URGENT Field Safety Notice

Trilogy Evo, Trilogy Evo O2, Trilogy EV300
Flow Sensor Nebulized Aerosol Deposition

Reference: Flow Sensor Nebulized Aerosol Deposition
Trilogy Evo, Trilogy Evo O2, and Trilogy EV300
2024-CC-SRC-013

Figure 1: Acceptable In-Line Nebulizer Placement.

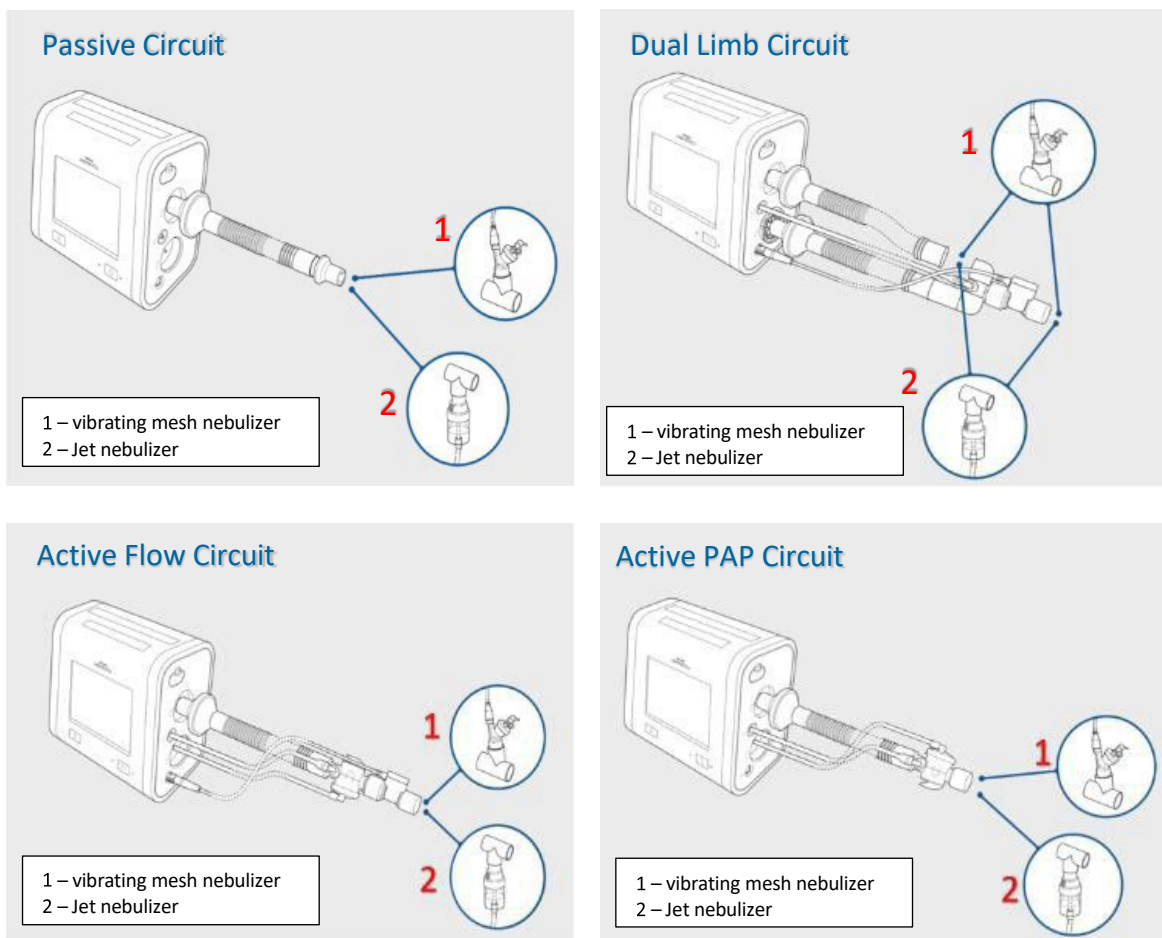
- If using in-line nebulizer treatments:
 - The circuit must be configured as pictured in the images in **Figure 1** below
 - For prescriptions needing tidal volumes greater than 700 mL with a passive circuit, transition patient to alternate circuit (Active PAP, Active Flow, or Dual Limb).
